**TOWN OF NEWBURGH
PLANNING BOARD
TECHNICAL REVIEW COMMENTS**

PROJECT NAME: BARTON SITE PLAN/LOT LINE CHANGE
PROJECT NO.: 2021-08
PROJECT LOCATION: SECTION 97, BLOCK 2, LOT 27.32, 40 & 47
REVIEW DATE: 29 SEPTEMBER 2021
MEETING DATE: 7 OCTOBER 2021
PROJECT REPRESENTATIVE: MECURIO-NORTON-TAROLLI-MARSHALL

The following comments are in response to a review by Patrick Hines of McGoey, Hauser, & Edsall Consulting Engineers, dated April 30, 2021:

Site Plan
for lands of
800 Auto Park Place, LLC

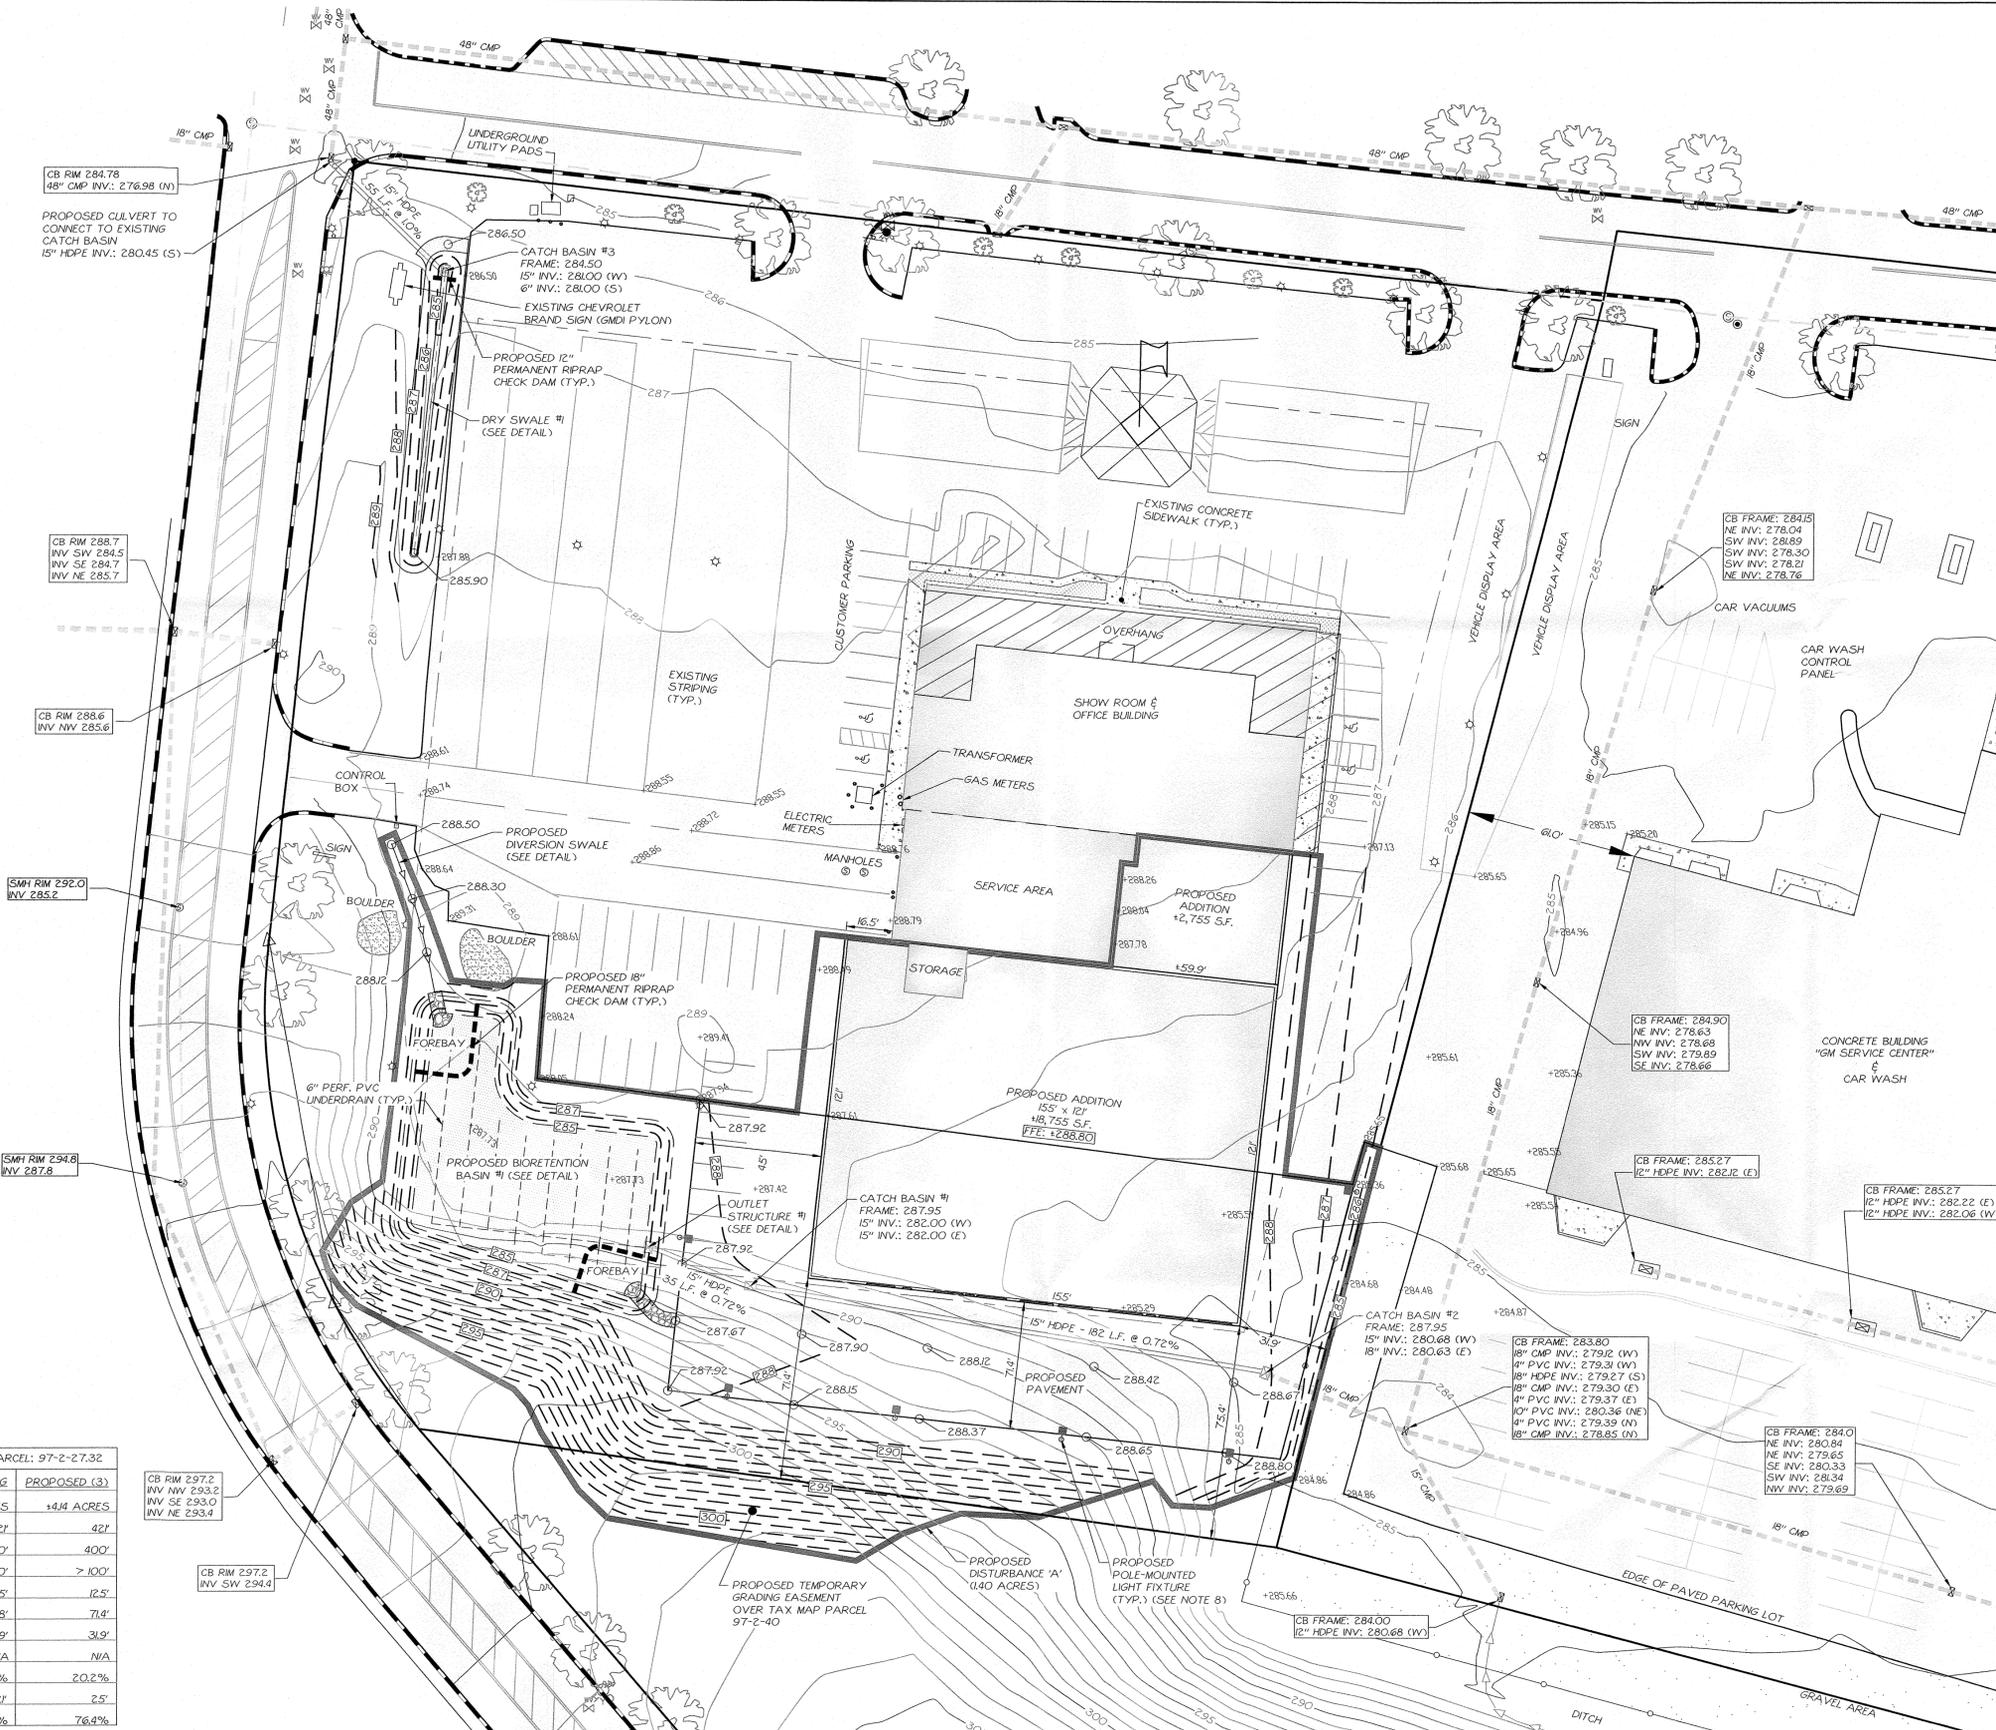
In addition to the responses above, we offer the following comments based upon the discussion at the May 6, 2021 meeting:

1. The previously proposed retaining wall has been removed. The southerly slope is proposed to be tied back to existing grade.
2. A landscaping plan has been included in the detailed site plan.
3. An updated building elevation, including exterior finish specifications, has been included in the current submittal. The exterior colors on the proposed addition will be consistent with the existing building.
